SUBJECT: Calvert Cliffs Nuclear Power Plant
Unit No. 1; Docket No. 50-317
Core Operating Limits Report for Unit 1 Cycle 15, Revision 3

CORE OPERATING LIMITS REPORT

UNIT 1, CYCLE 15

REVISION 3

Figure 3.2.1-2

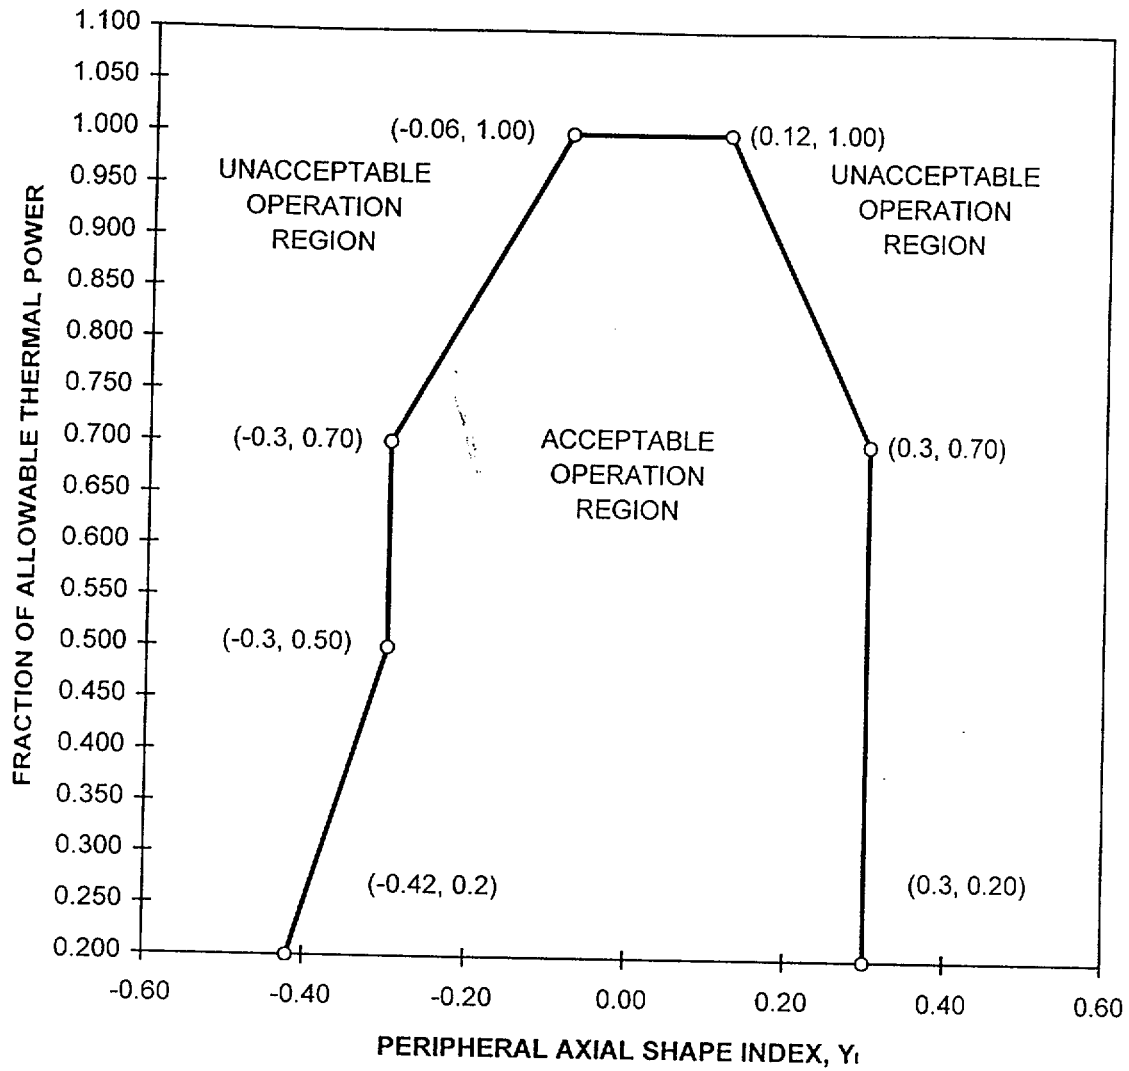
COLR Figures 3.2.1-2 & 3.2.5 are revised to reflect a 20% LCO monitoring floor for LHR and DNB ASI limits (SE00433, Rev. 0000).

Figures 3.2.1-2, 3.2.1-3, & 3.2.5 are revised to provide clarification in reference to NEOP-13. Section 3.2.1 & Figure 3.2.1-3 were also revised to provide clarity. Finally, Figures 3.2.2 & 3.2.3 were revised to correct an inaccuracy in the peaking factor Tech Specs (SE00451, Rev. 0000).

(LCO Limits are not needed below 20% thermal power)

(See NEOP-13 for Administrative Limits)
